**From:** Head, Scott [smhead@STPEGS.COM]  
**Sent:** Tuesday, February 22, 2011 2:57 PM  
**To:** Tai, Tom; Tonacci, Mark; Wunder, George  
**Subject:** Paper for SSI Sensitivity Studies for Cracked Concrete and Soil Separation Cases  
**Attachments:** SSI Sensitivity Analysis of Cracked Concrete 02222011.doc

## SSI Analysis Sensitivity Studies for Cracked Concrete and Soil Separation Cases

Comparison of GMRs with the Input Spectrum (Horizontal)

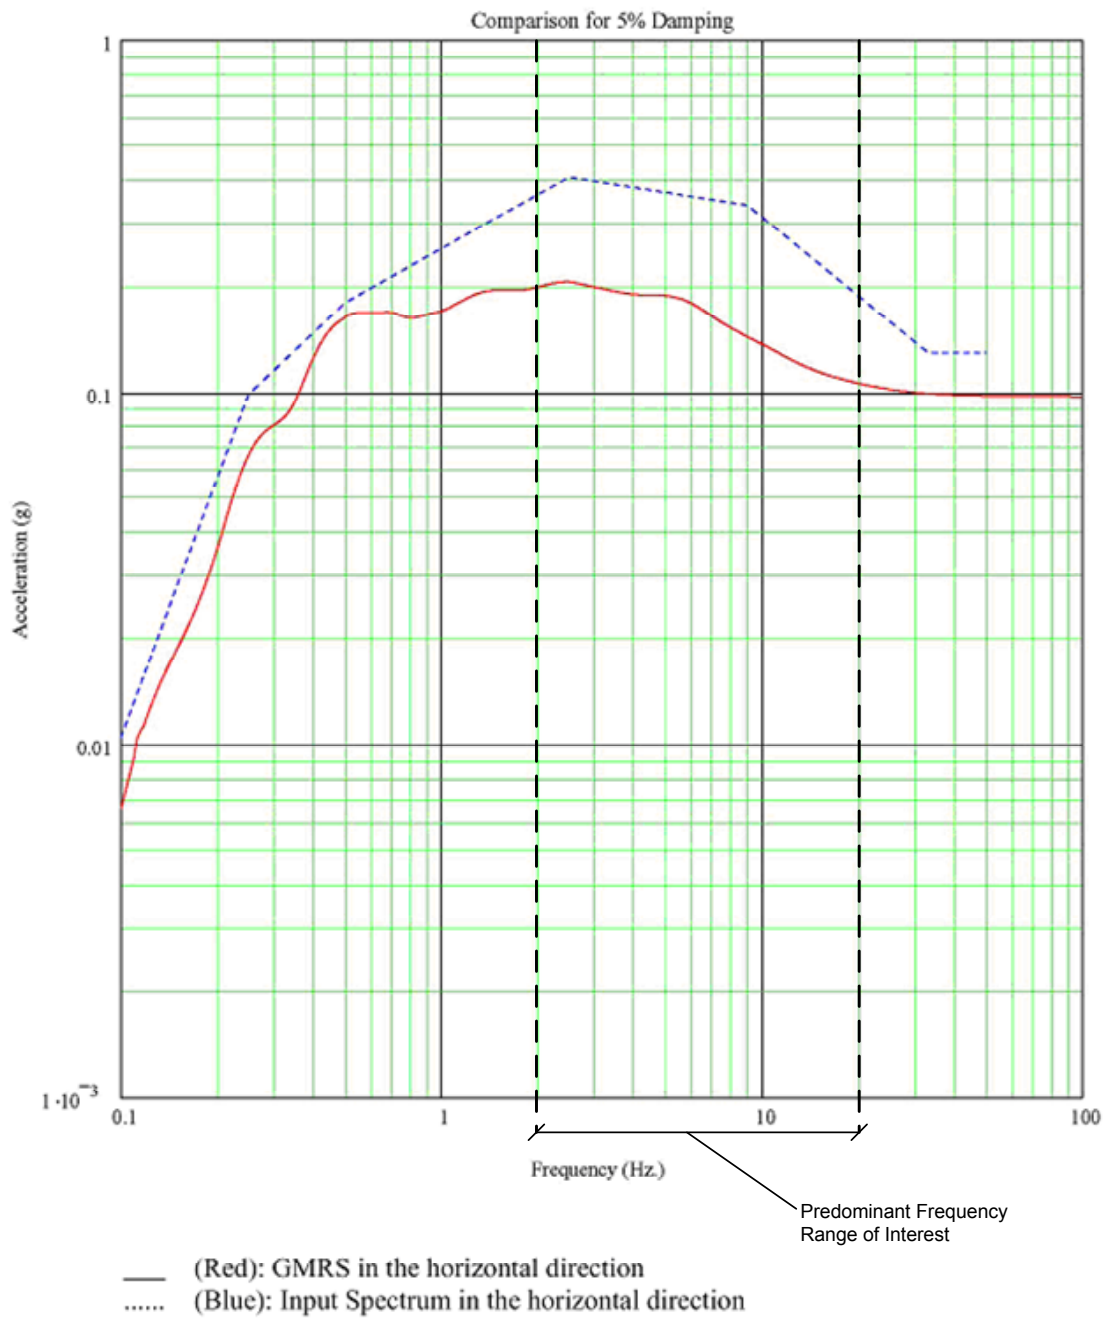
The NRC Staff has requested additional justification for not analyzing the soil separation, cracked concrete and empty fuel tank for the Lower Bound and Mean soil cases, in addition to the sensitivity studies that were done for the Upper Bound soil case. NINA believes that the sensitivity studies for the Upper Bound case are adequate to accomplish the purpose of these sensitivity studies.

- The sensitivity analyses for the STP 3&4 Diesel Generator Fuel Oil Storage Vault (DGFOSV) and the Diesel Generator Fuel Oil Tunnel (DGFOT) also were done for only one soil profile, i.e. the Upper Bound soil case. The NRC Staff has now asked for further justification for not also running the cracked concrete and soil separation analyses for the Lower Bound and Mean soil properties.

1. The attached figure shows that the site-specific SSE response spectrum which we are using for plant design has significant margin over the GMRS in the frequency range of interest to our design. In the figure, the horizontal GMRS that SRP 3.7.2 requires to be considered in the seismic analysis for determination of the plant design loads is represented by the lower curve. However, the site-specific Category I structures, including the Diesel Generator Fuel Oil Storage Vault and the Diesel Generator Fuel Oil Tunnel, were conservatively designed for horizontal accelerations represented by the Input Spectrum, which is the upper curve of the figure. As such, seismic loading used to design the plant is based on accelerations that are essentially double the regulatory requirements in the predominant frequency range of interest.

We have satisfied the SRP requirements, and the design incorporates substantial margin to account for any potential uncertainties. This issue should be considered resolved.
